**RCE6909 – JL Brierley Ltd**

The following arrangement has been revised with respect to the protection of the canal boundary wall at the JL Brierley project. I am satisfied that the manufacturers state that it is suitable for restraint against the relevant potential HGV loadings as set out in BS6180 and BS6399 (and the relevant Eurocode standards), provided the posts are at 1.6m centres.

Figure 1 – Proposed barrier formation

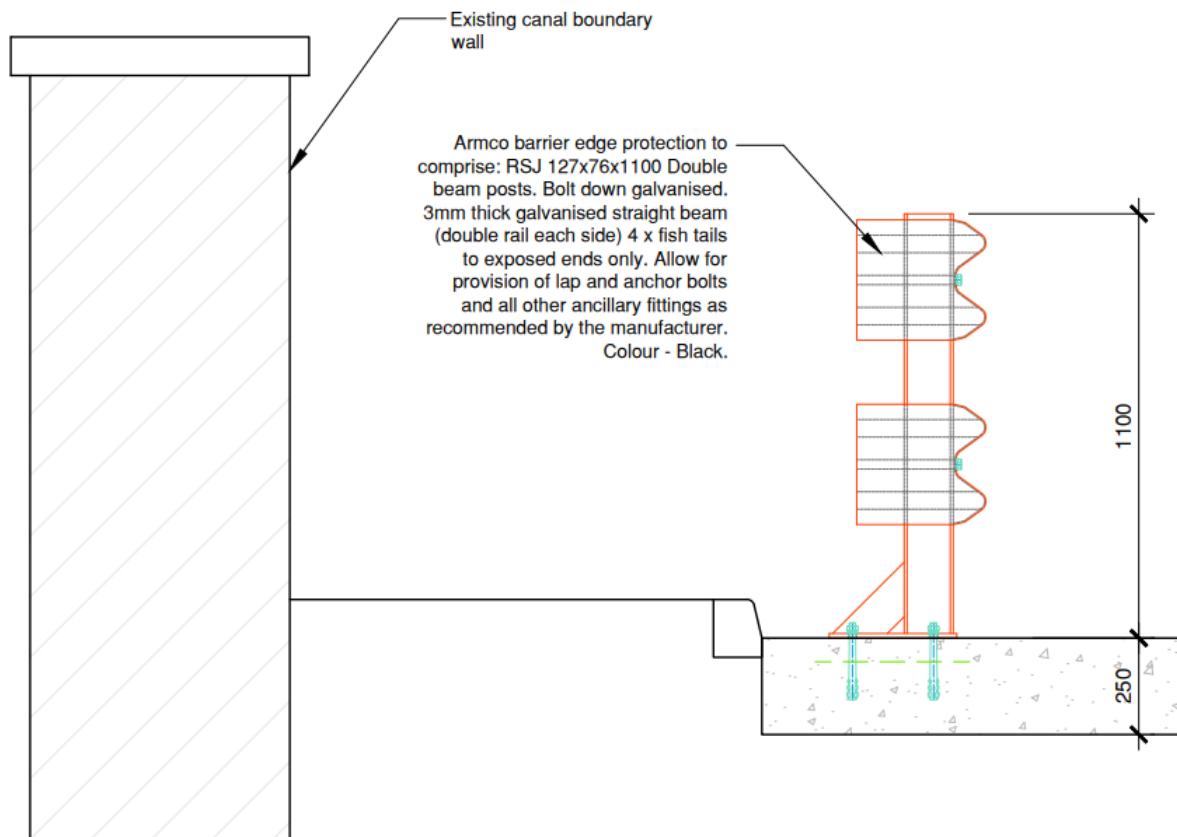
The reinforced concrete base slab at a depth of 250mm can easily accommodate the loadings applied.

Refer to Figure 1 for proposed detail.
